Reference: HFW Holdings Limited
Site Plan Application Submission 3
395 Queensway West, Simcoe (Northern Parcel)
Our File 22-013

G. Douglas Vallee Limited has reviewed the Submission 2 site plan application comments by Norfolk County for application SPPL2024179. Please find the following items enclosed as part of our 3rd site plan application submission:

22-013 HFW - 395 Queensway - Northern Parcel

Development Application: SPPL2024179

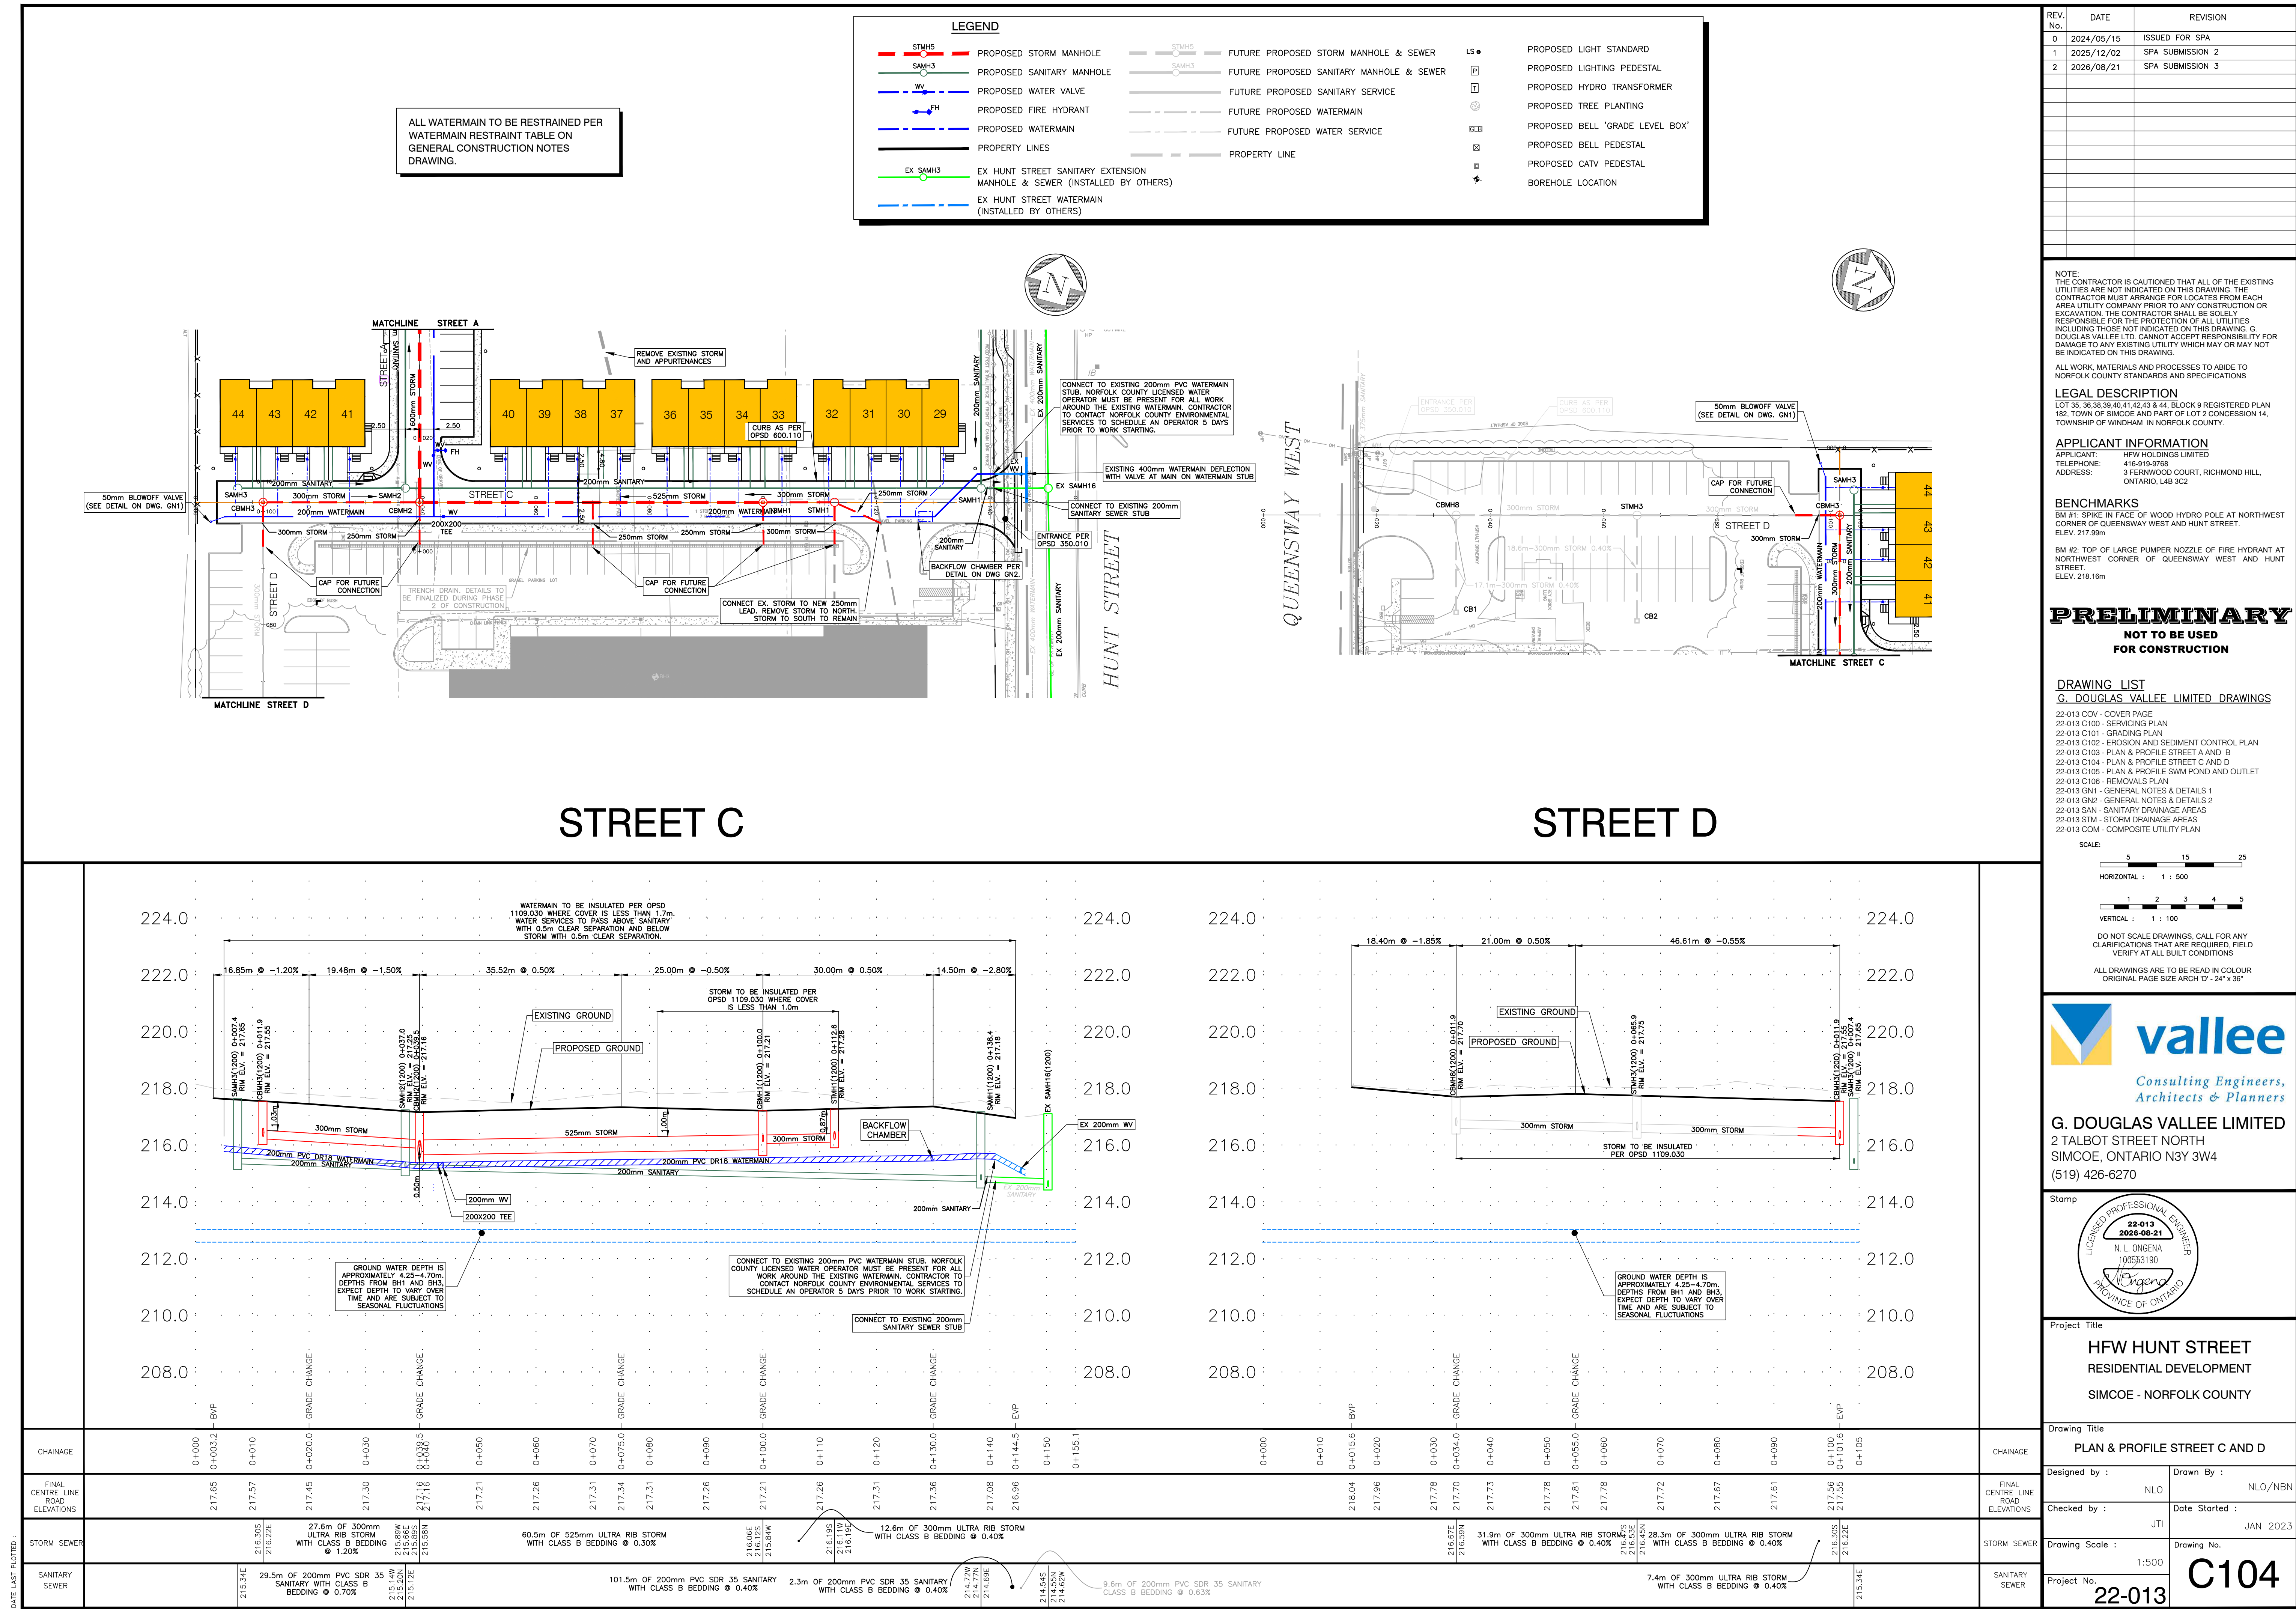
2nd Submission	Development Engineering C101 - Grading Plan	18	10-Apr-26	Include additional surrounding grades that indicate the site is self-contained and does not accommodate additional external flows from adjacent properties.	Contours from Norfolk's GIS confirm that stormwater runoff from #24 and #26 Hunt Street (located at the north side of the development), flows overland in a northerly direction towards Patterson Creek. A site visit was completed to confirm the area from #415 Queensway West that contributes runoff to the development site. This areahas been added to the SWM model and accounted for in the storm drainage areas and design sheet.		Complete
2nd Submission	Development Engineering C101 - Grading Plan	19	10-Apr-26	Please note that the private pond does not require direct access from the Hunt St. ROW, as it will not be assumed as a municipal asset.	Noted. The pathway to Hunt Street is as a walking path.		Complete

2nd Submission	Development Engineering C101 - Grading Plan	20	10-Apr-26	Illustrate the ponding level of the 100-year storm event within the site area. Per Section 7.4.00, ponding can be accommodated within parking areas to a limit of 0.3 meters in depth.	As illustrated by the grades shown on Drawing C101, the maximum ponding depth within the roadway/parking area are as follows: - CBMH1 ponds to an elevation of 217.31 (0.13m above the CBMH grate elevation) - CBMH2 ponds to an elevation of 217.27 (0.11m above the CBMH grate elevation) - CBMH3 has no ponding (not a low point) - CBMH4 ponds to an elevation of 217.18 (0.12m above the CBMH grate elevation) - CBMH5 ponds to an elevation of 217.16 (0.15m above the CBMH grate elevation) - CBMH6 ponds to an elevation of 217.16 (0.13m above the CBMH grate elevation) Therefore ponding will never exceed 0.3m before spilling towards the SWM Pond.		Complete

2nd Submission	Development Engineering C101 - Grading Plan	21	10-Apr-26	Rear yard swale behind Lot 1-12 flows directly into the SWM Pond without a formal inlet design.	Correct. Runoff from behind lots 1-12 flows directly into the SWM pond via overland flow. As the proposed swale grade is less than the required slope of 2.0%, a swale subdrain will be installed under the swale per the detail on DWG C101 - Grading Plan, which will outlet directly to the SWM pond.		Complete
2nd Submission	Development Engineering C101 - Grading Plan	22	10-Apr-26	Show underside of footing elevation for all townhouse blocks. Include a note, 'A minimum of 0.5m minimum is required between the USF and seasonably high groundwater level'.	Noted. Note have been added.		Complete
2nd Submission	Development Engineering C101 - Grading Plan	23	10-Apr-26	All lot surfaces shall be constructed to a minimum grade of 2%, the maximum lot surface grade for yards shall be 6%. See Lots 1, 16, 28, 29, 41, 43 & 44.	Noted. Grading has been revised such that all rear yard lot surface grades are between 2.0% and 6.0%.		Complete

2nd Submission	Development Engineering C101 - Grading Plan	24	10-Apr-26	Rear and Side yard swales shall have a minimum slope of 2.0%. Maximum depth for all swales shall be 0.5m. Maximum side slope on any swale shall be 3:1.	Noted. Grading has been revised to achieve minimum rear and side yard swale slopes of at least 2.0% where possible. Where swales are less than 2.0%, subdrains shall be installed per the detail provided on DWG C101 - Grading Plan and DWG C100 - Servicing Plan complete with connection to the proposed storm sewer or SWM pond as applicable. All swales are a minimum of 1.0%. Refer to the email correspondence with Norfolk County dated April 15, 2026 which confirms this approach.		Complete

2nd Submission	Development Engineering C101 - Grading Plan	25	10-Apr-26	Please include roadway and curb radii dimensions on this drawing per Section 16.4.02. As noted in the details, the minimum pavement width of a multiple unit development roadway for two-way traffic with no street parking shall be 7.30m.	Noted. Roadway and curb radii dimensions have been added.		Complete
2nd Submission	Development Engineering C101 - Grading Plan	26	10-Apr-26	Per the Geotechnical report, the minimum pavement design shall be: a. 40mm of HL3 b. 60mm of HL8 c. 150mm of Granular A d. 300mm of Granular B	The light-duty and heavy-duty pavement structures specified meet the minimum recommended pavement structures thicknesses outlined in the geotechnical report and adheres to Norfolk County Design Criteria 16.05.02 for new multiple unit development roadways (40mm HL3, 50mm HL8, 150m Gran A and 300mm Gran B).		Complete

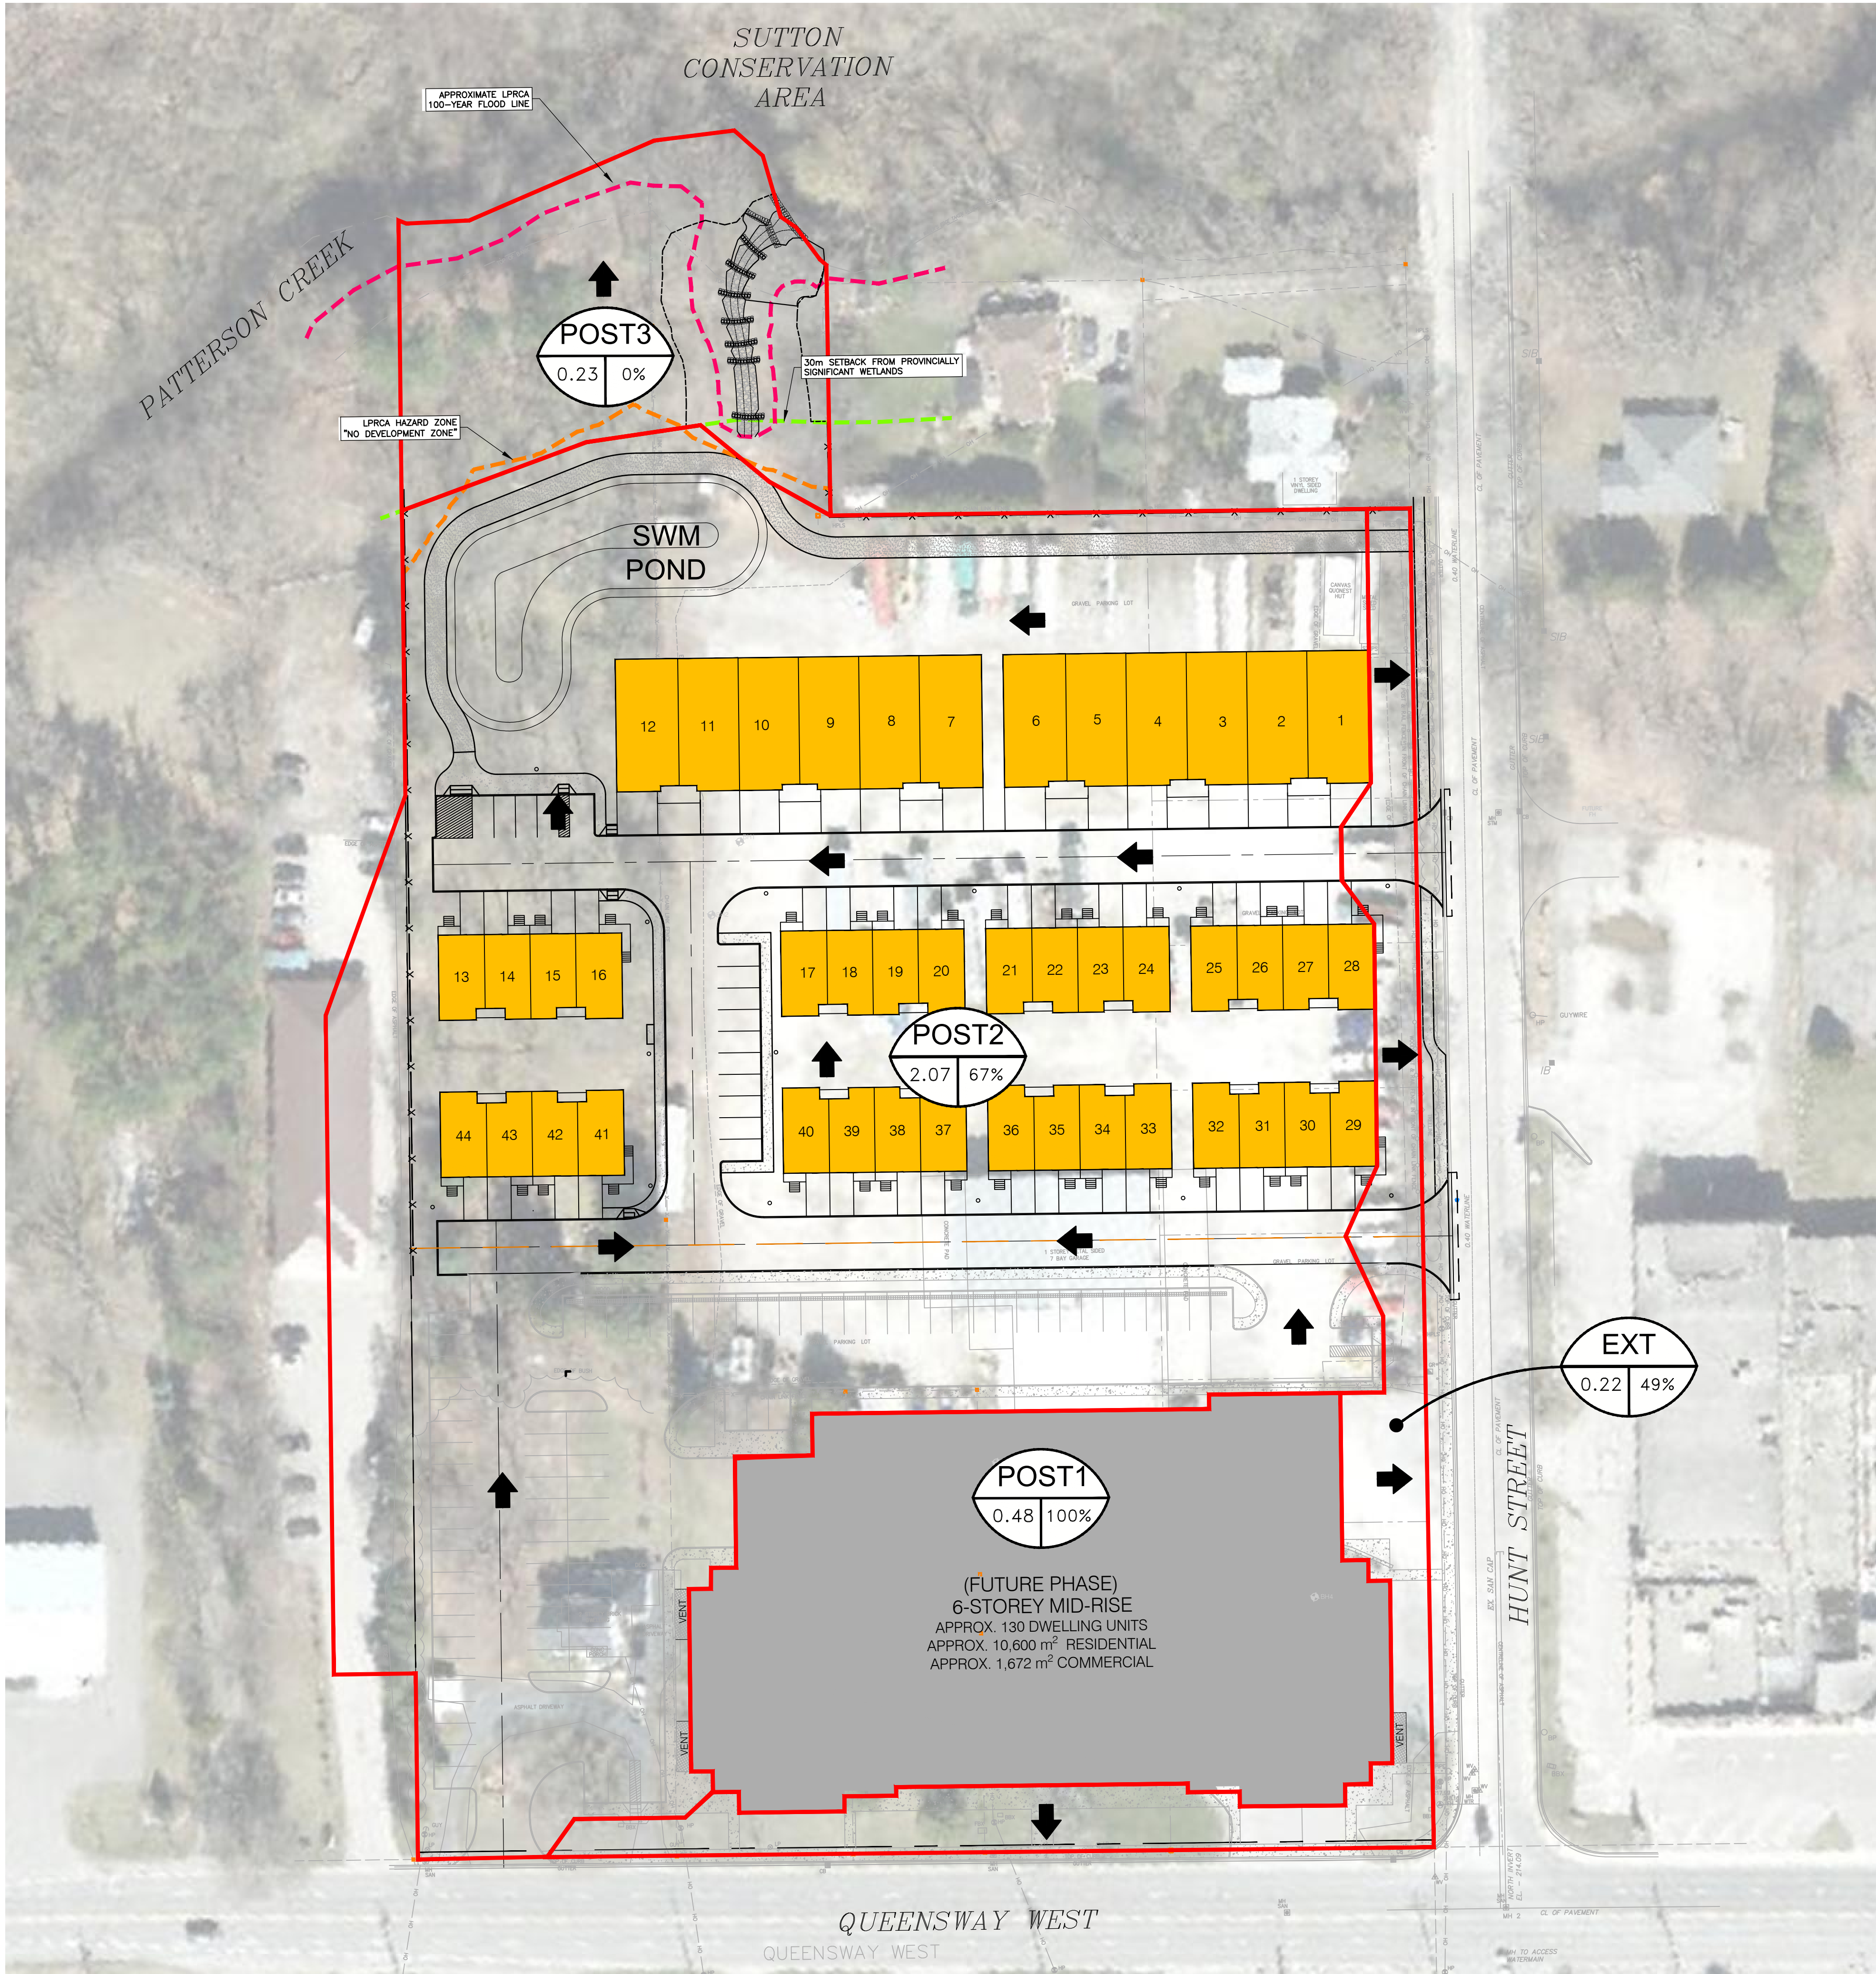
2nd Submission	Development Engineering SWM Report	7	10-Apr-26	Include updated Post-Development Drainage Area Plans in this report.	An updated Post-Development Drainage Area Plan is included in Appendix E of the SWM Report.		Complete
2nd Submission	Development Engineering SWM Report	8	10-Apr-26	Please confirm the OGS has been sized for both Phase 1 and 2 of the development lands.	The OGS was sized for both the Phase 1 and 2 development lands. Refer to the OGS sizing parameters in Appendix A of the SWM report and the detailed sizing report from Hydroworks in Appendix C of the SWM Report.		Complete
